Mobile Intel® Pentium® 4 Processor-M

Specification Update

June 2004

Document Number: 250721-024

Figure 2. System Bus Reset and Configuration Timings

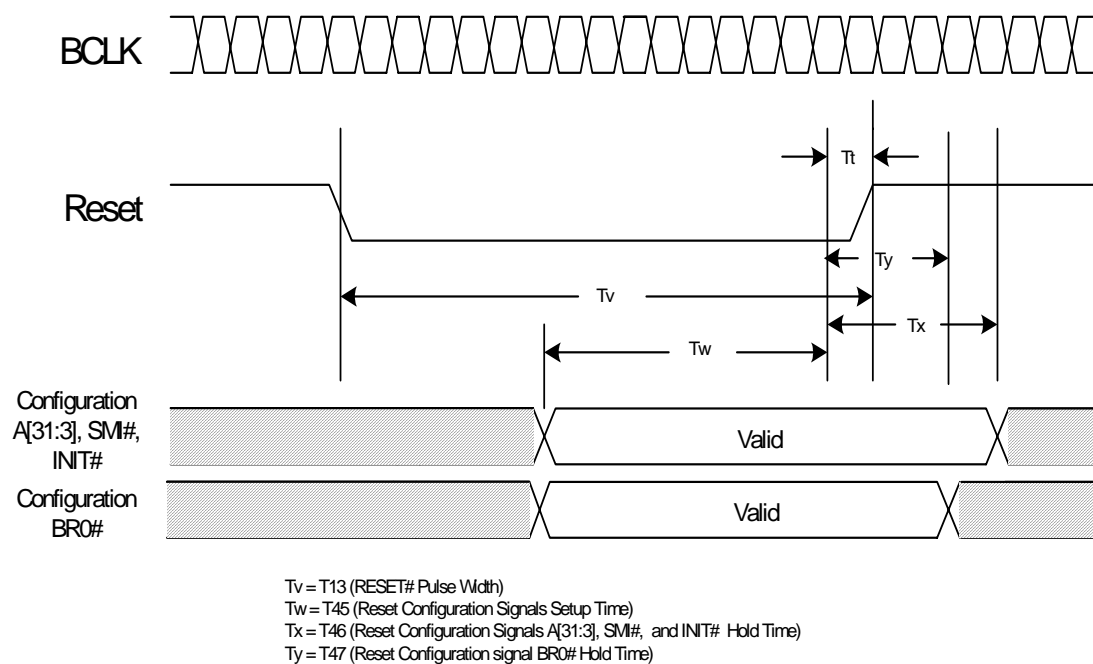
T2. BR0# Maximum Hold Time Specification Change

The BR0# maximum hold time has changed to 2 BCLKs. This change will be shown in the “System Bus AC Specifications (Reset Conditions)” table and “System Bus Reset and Configuration Timings” figure of the *Mobile Intel® Pentium® 4 Processor - M Datasheet*. This change will be incorporated in the next revision of the datasheet.

The following figure will be modified to reflect this change:

T# Parameter	Min	Max	Unit	Figure	Notes
T45: Reset Configuration Signals (A[31:3]#, BR0# INIT#, SMI#) Setup Time	4		BCLKs	13	1
T46: Reset Configuration Signals (A[31:3]#, INIT#, SMI#) Hold Time	2	20	BCLKs	13	2
T47: Reset Configuration Signal BR0# Hold Time	2	2	BCLKs	13	2

1. Before the deassertion of RESET#.
2. After clock that deasserts RESET#.
